December 2, 2014

RE: Structural Review Monterey School

edm Project No.: TOM-3839

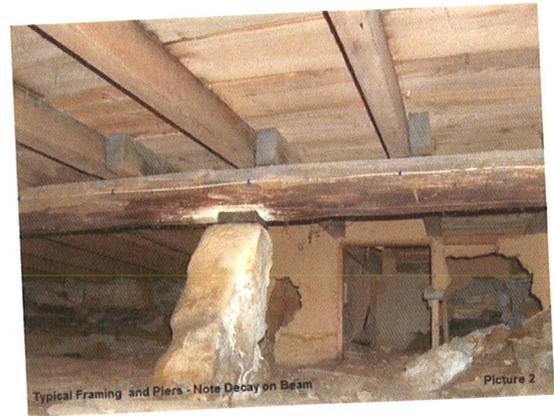
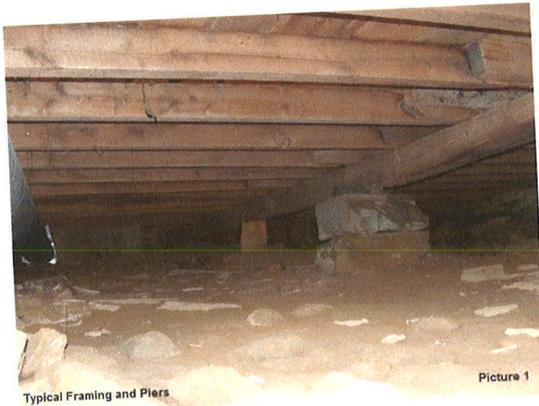
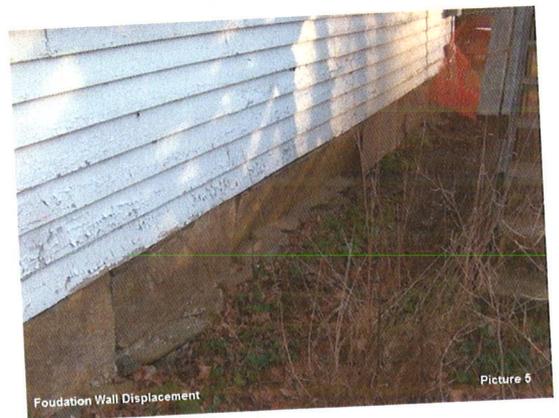
5. It was noted to be extremely damp in the crawl space below the building. See Pictures 1, 2, and 3. This should be addressed by increasing the ventilation of the crawl space area, and installing a layer of polyethylene on the crawl space floor (lapping and sealing joints of the polyethylene).

6. Decay was noted in both the first floor joists and beams. See picture 2. In particular at the pier location opposite the crawl space entry where the decay had allowed the beam to settle $\frac{1}{2}$ inch onto the stone pier. This should be addressed at the same time as item 7.
